Bid 639
New HVAC Modernization Project for Pacifica High School

BID CLARIFICATION ADDENDUM #1

Dated: October 18, 2020

**DEMO CEILING
 PLAN - BLDG F -
 2F**

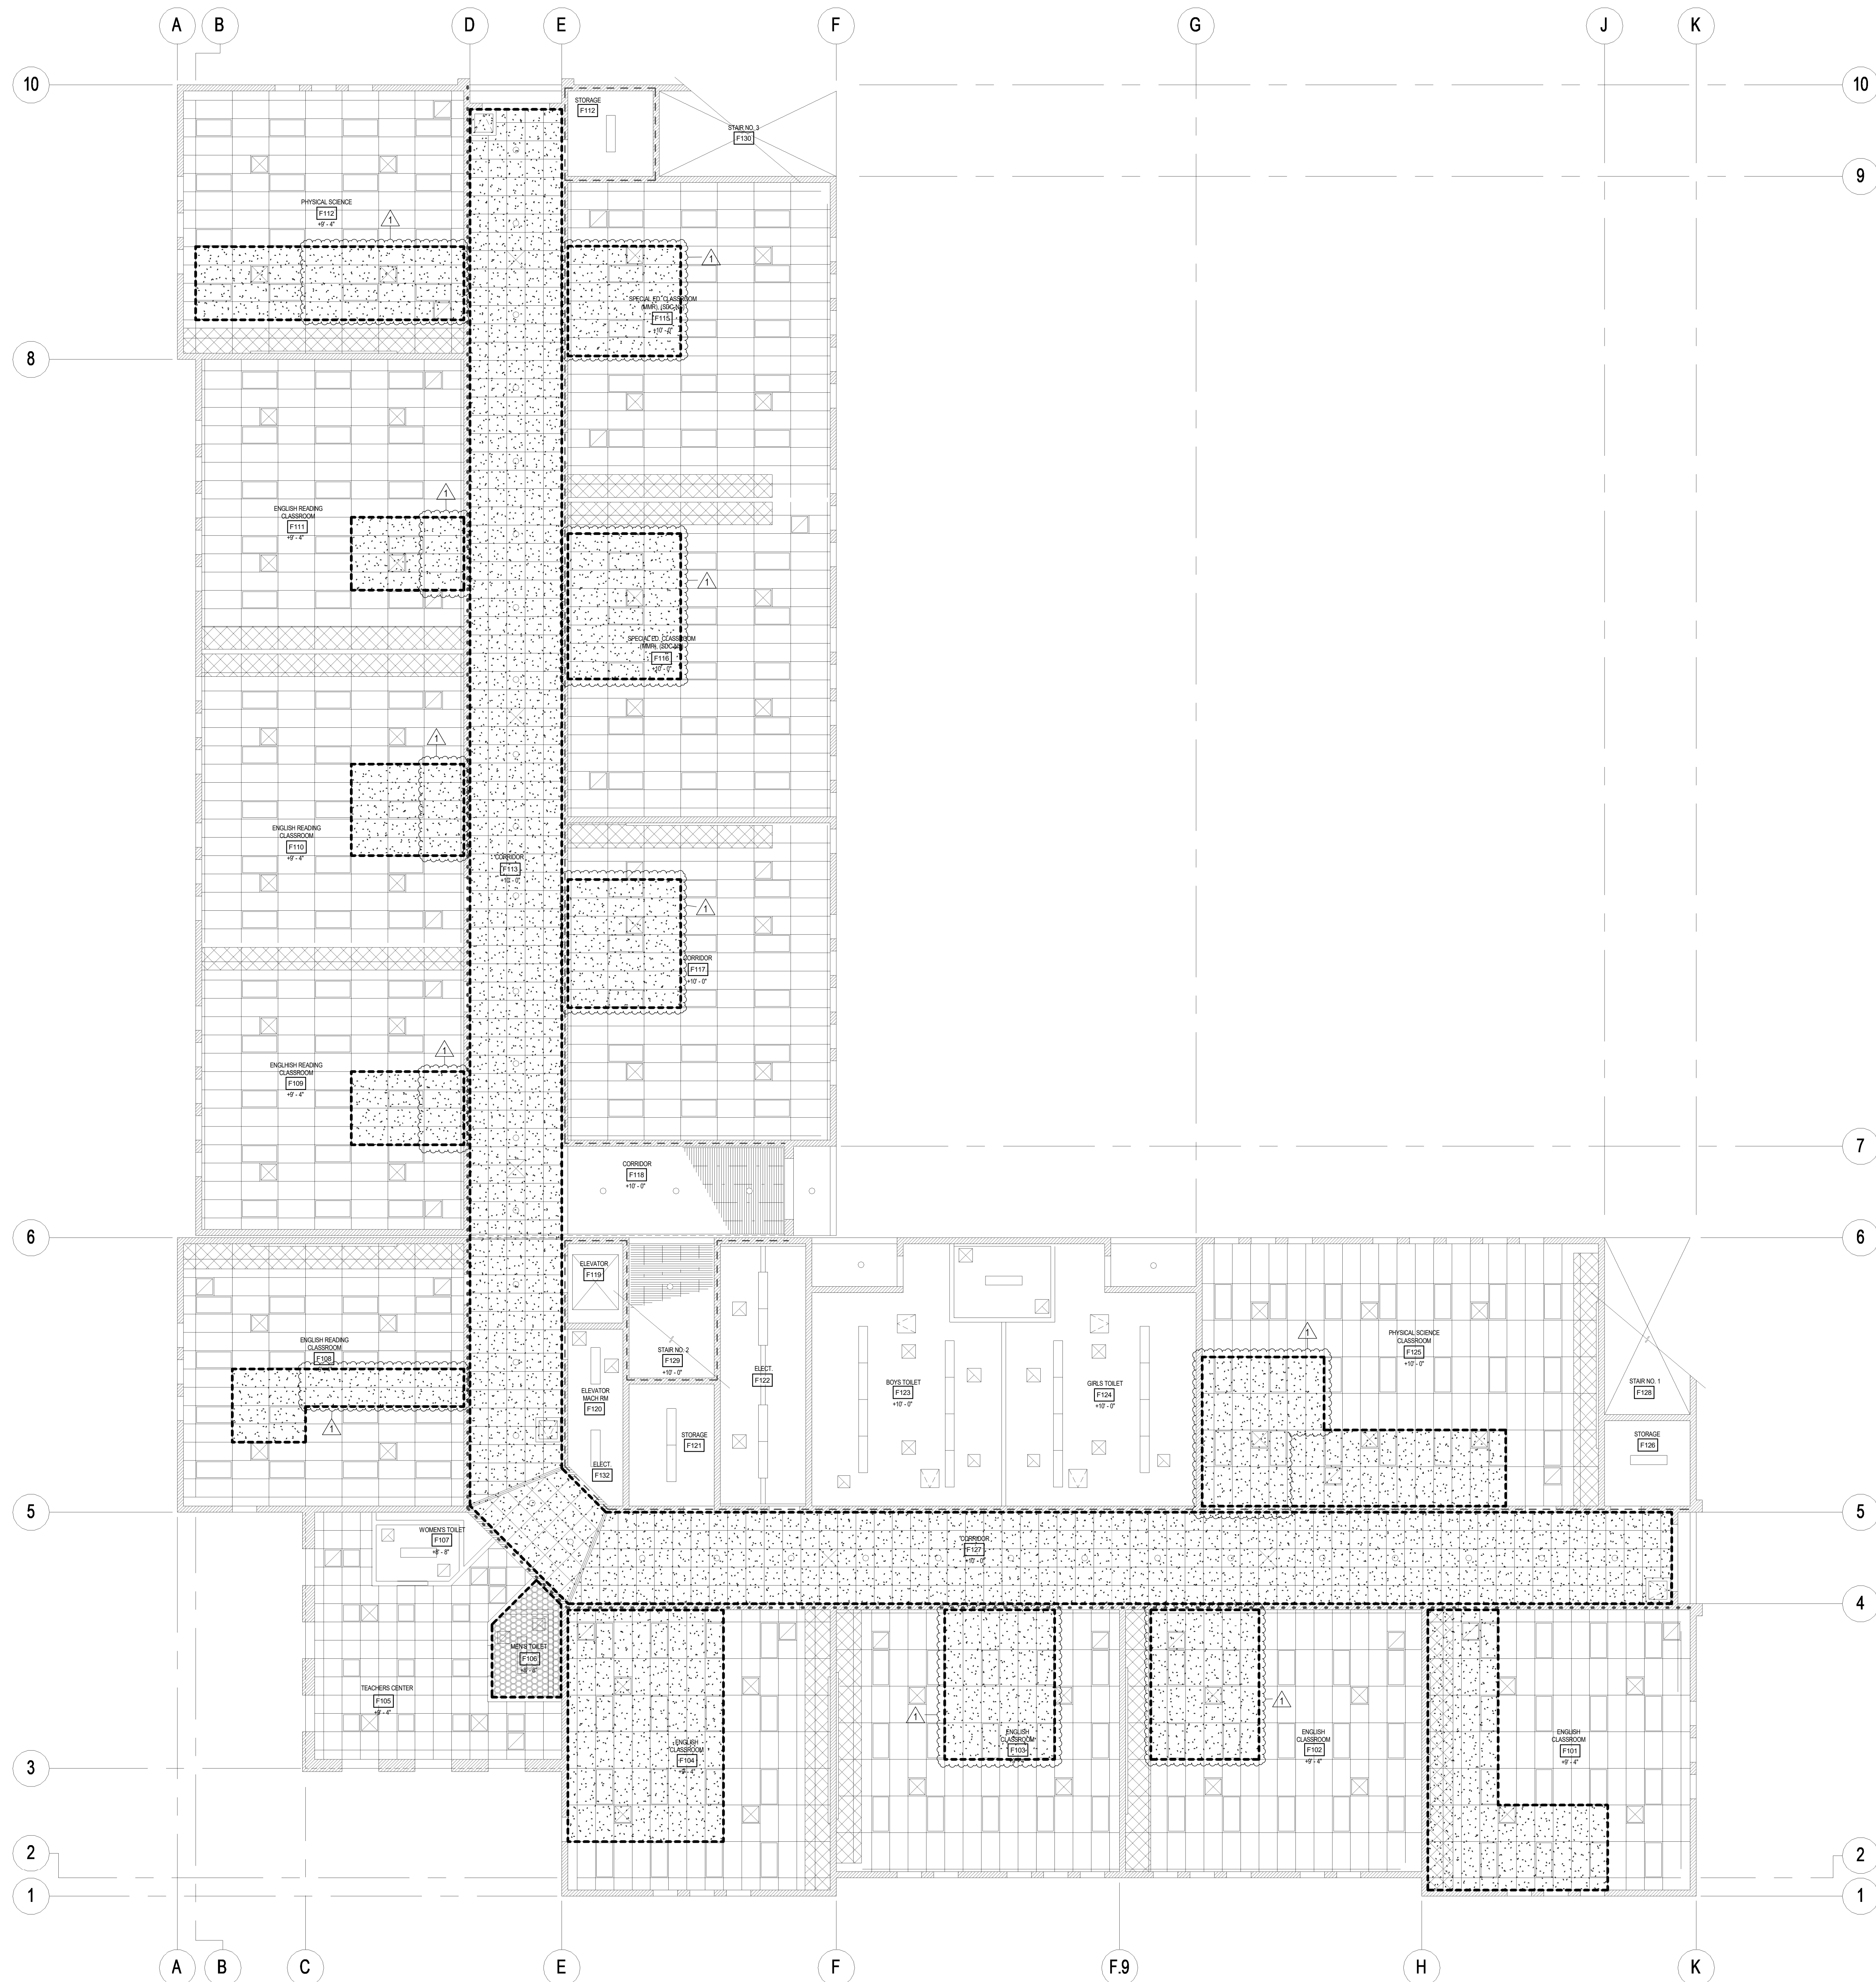
1.32 DRAWING AF3.1 DEMO CEILING PLAN - BLDG F - 2F

- A. Replace DSA approved Drawing AF3.1 in its entirety with the attached revised Drawing AF3.1. (Drawing appeared to have the first-floor drawing shown, not the second floor, so we replaced the entire drawing.)
